**CITY OF SAINT PAUL
HERITAGE PRESERVATION COMMISSION STAFF REPORT**

FILE NAME: Third Street East Reconstruction, between Maple and Arcade

DATE OF PUBLIC HEARING/PERMIT REVIEW: March 26, 2015

HPC SITE/DISTRICT: Dayton's Bluff Heritage Preservation District

STANDARD DETAIL PLATES
CONSTRUCTION DETAILS
MAPLE STREET DETAIL

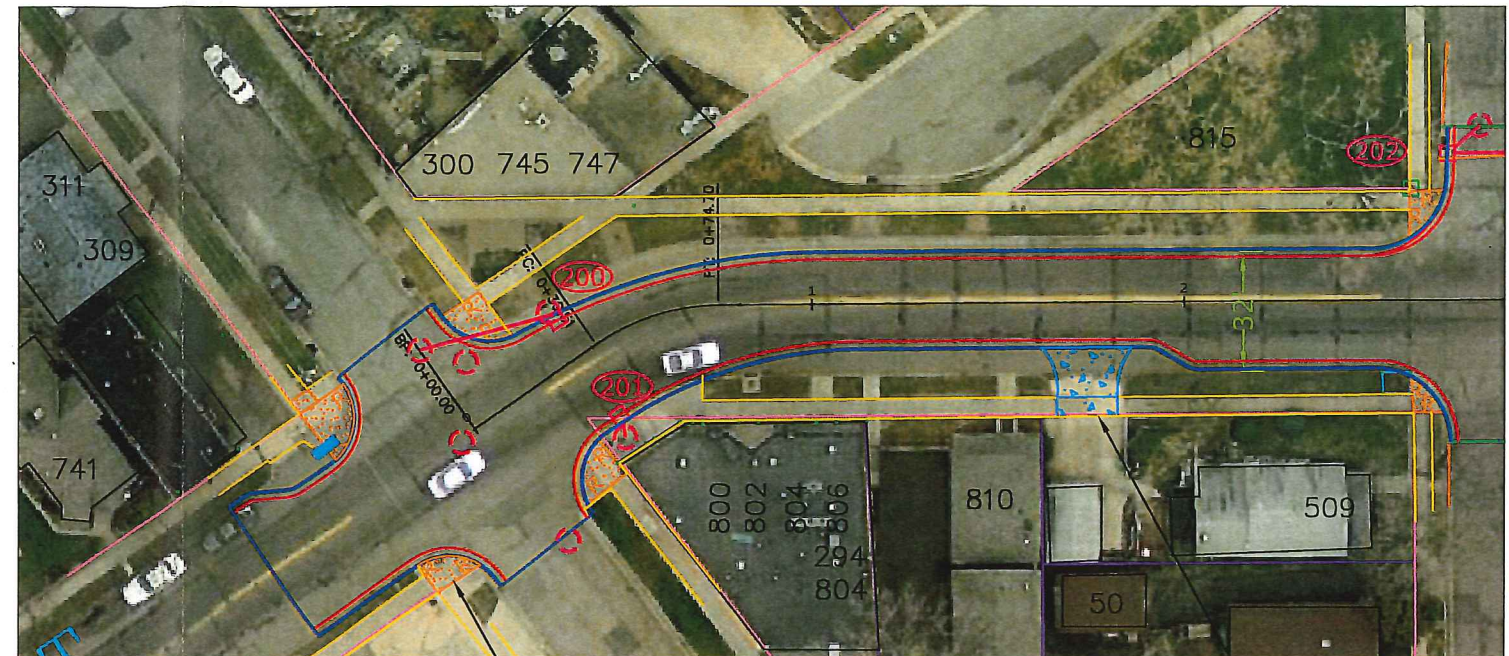
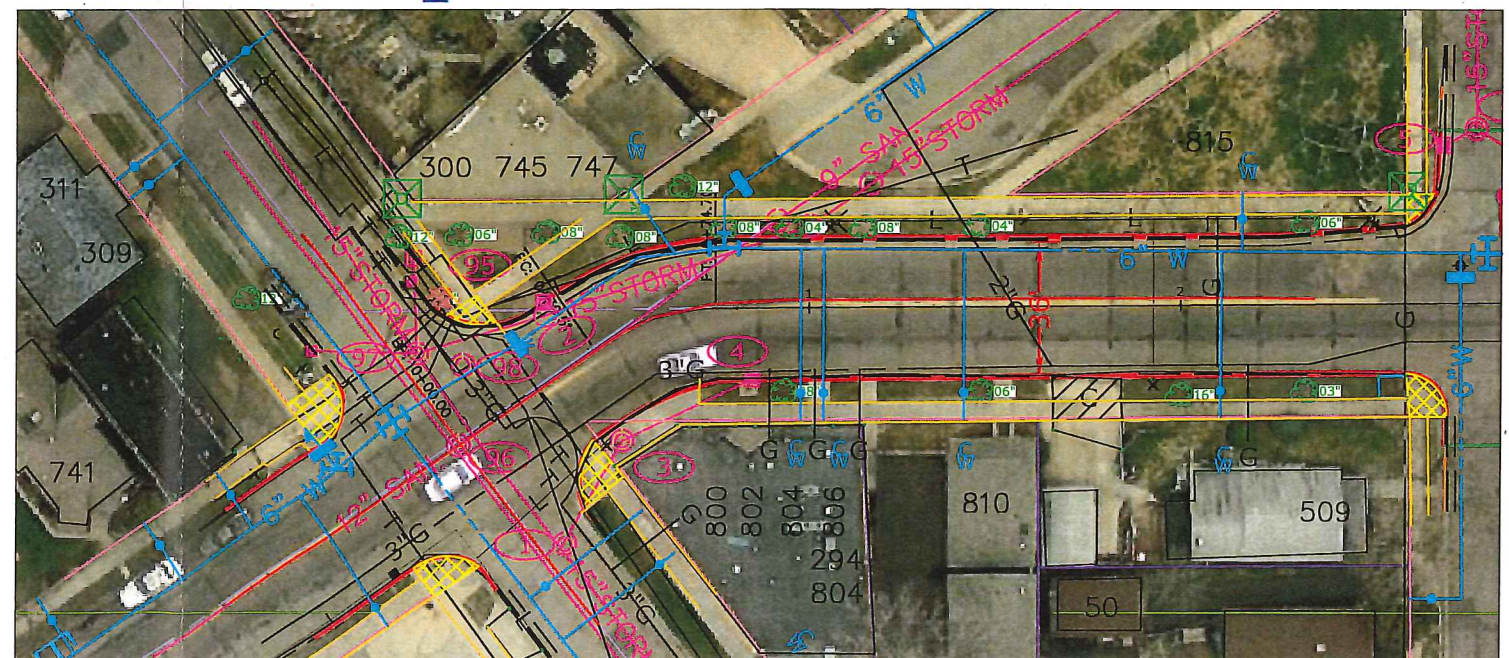
Only one bump-out is proposed at the Maple and Third intersection and an elongated "bump-out" and widening of the boulevard is created on the south side between Maple and Arcade with the narrowing. This is also to still preserve a drop-off area and bus stop for this block. These two areas appear to have been altered minimally in the past and still generally recall an early grid pattern. Altering these two areas doesn't fully

comply with these guidelines, however the elongated "bump-out" will not be visible as a modern corner bump-out. The bump-outs are not designed in a way that if *removed in the future, the essential form and integrity of the structure would be unimpaired* as they are integral with the sidewalk and boulevard. All solutions to increase safety while preserving the historic character and integrity of the streetscape should be explored before resorting to altering the historic pattern.

traffic concerns at Maple and Third Streets have been fully explored. For example, if this intersection was controlled with a 4-way stop or stop lights, are the curb alterations necessary. This shall be done prior to any work commencing and shall be presented to the HPC for consideration.

5. The standard ADA ramps are acceptable at all intersections but if space allows should have two split ramps instead of the full radius.
6. The revisions shall be incorporated into the plans for final staff review and approval.
